COMMITTEE OF THE WHOLE JUNE 4, 2001

**SITE DEVELOPMENT APPLICATION
ISLAMIC SHIA ITHNA-ASHERI JAMAAT OF TORONTO
FILE: DA.00.124**

ATTACHMENT '2B'
SITE PLAN LAYOUT

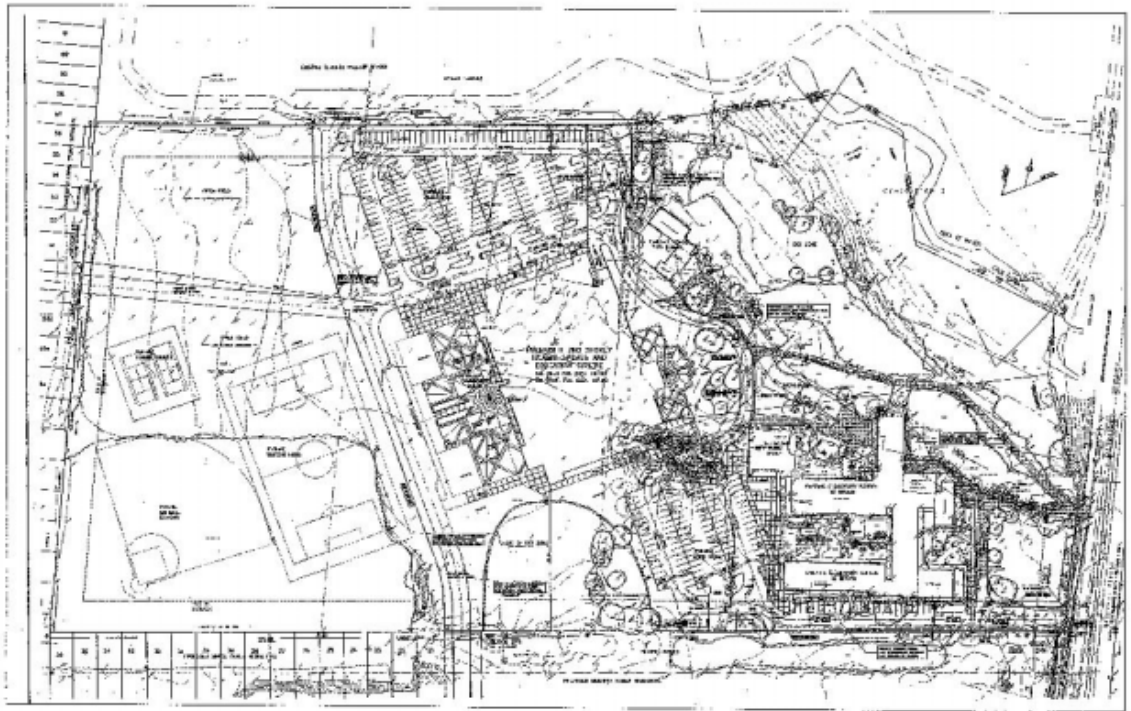
- The Region requires that the existing detail of Bathurst Street shown on the site servicing and grading drawing be extended to a point 125m south of the existing southerly site access. This detail to include the existing driveway of the townhouse development located approximately 65m south of the site.
- The site servicing and grading drawing must also include the conceptual detail of the proposed new intersection located 125m south of the site.
- The Region has reviewed the Traffic Impact Study and Parking Report prepared by Marshall Macklin Monaghan and has a concern with the amount of storage required for left turns into the site. The Consultant should detail the amount of left turn storage required and the impact on the southbound Bathurst Street left turn movements. Should there be a conflict with the opposing left turn

movements, the existing northerly access to the site may be dedicated as the main point of access.

- The Owner is to convey a road widening along Bathurst Street, to the Region. The widened streetline is to be graded to an elevation sufficient to provide a positive 2% slope from the top of the existing curb and gutter. The backslope of the regraded area should be set at a 3:1 slope to provide ease of lawn maintenance.

- This Department has a concern with regard to the driveway design immediately adjacent to the southeast corner of the existing school. The driveway as proposed at the southwest corner of the existing school should be extended easterly in a direct line to the Bathurst Street right-of-way to eliminate the existing jog at the southeast corner of the building.

- The southerly access should be regraded to provide better access to and from Bathurst Street. Maximum slope to be 4%. The driveway requires widening to provide a throat width of 9.0m with 9.0m radii.

- Construction access for the site should be located at the southerly site access.

The Region of York Transportation and Works Department and Vaughan Engineering Department must approve the proposed access points, road improvements and on-site traffic circulation, as a condition of site plan approval. The Region has advised that they will be a party to the City's site plan agreement.

ATTACHMENT '3'
LANDSCAPE PLAN

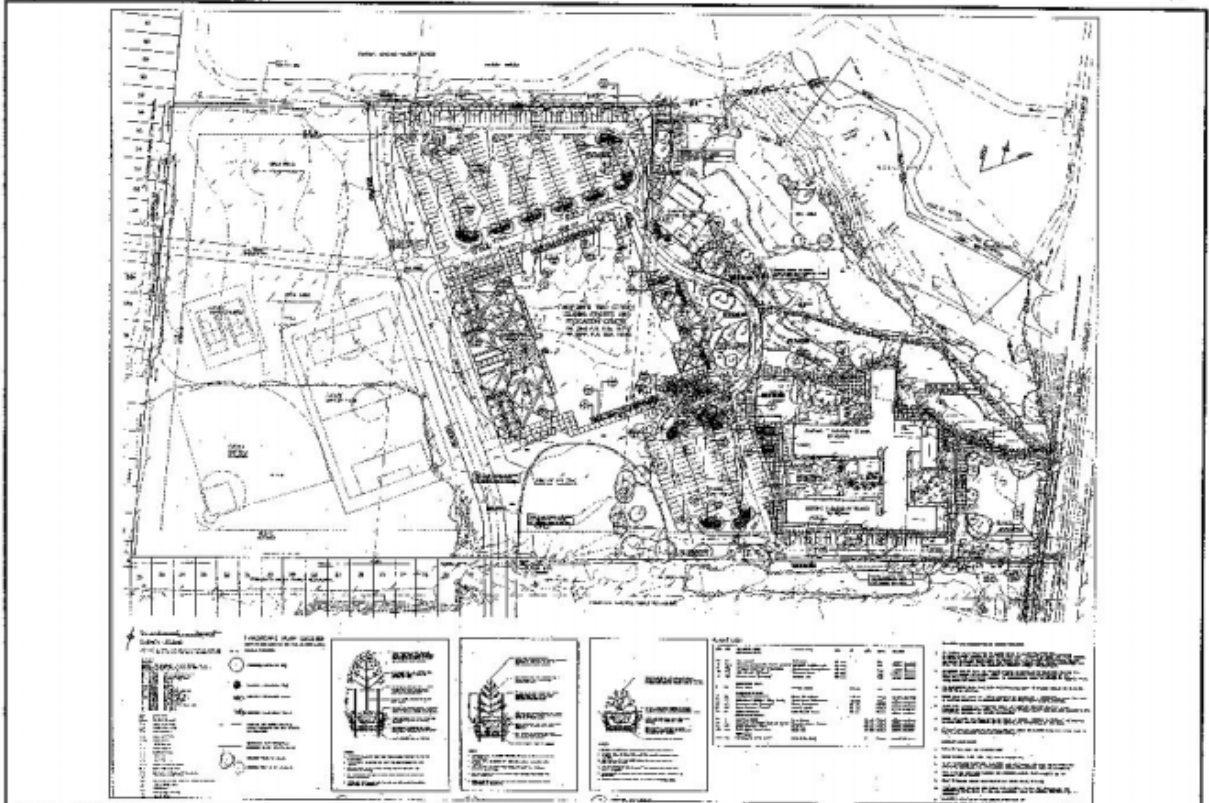
- Additional tree planting shall be required at the northwest corner of the site, along the property line abutting residential Lots #51 to #56 and along the south side of the Toronto Waldorf School.

- Location and construction details of curb cut for handicapped parking shall be included on the landscape plan.
- All existing and proposed fencing shall be indicated on the landscape plan. A wood privacy fence (to City Standards) shall be required along the perimeter abutting the residential areas.

- Areas within the tree protective fencing shall remain undisturbed and shall not be used for storage of building materials or equipment. No rigging cable shall be wrapped around or installed in trees. Surplus soil, debris or contaminants shall not be dumped within the protective fencing.

- Replacement of existing vegetation, stated for preservation, that has been damaged beyond repair, died or been destroyed shall be the responsibility of the applicant. The applicant shall replace all trees on a per diameter basis. If a 240mm caliper tree requires replacement, four trees of 60mm caliper will replace it. Replacement trees shall be an identical species (if possible) and shall be a minimum caliper of 60mm.

- A detailed landscape cost estimate including protective fencing etc., shall be submitted.

The final landscape plan and cost estimate shall be approved by the Urban Design Department.
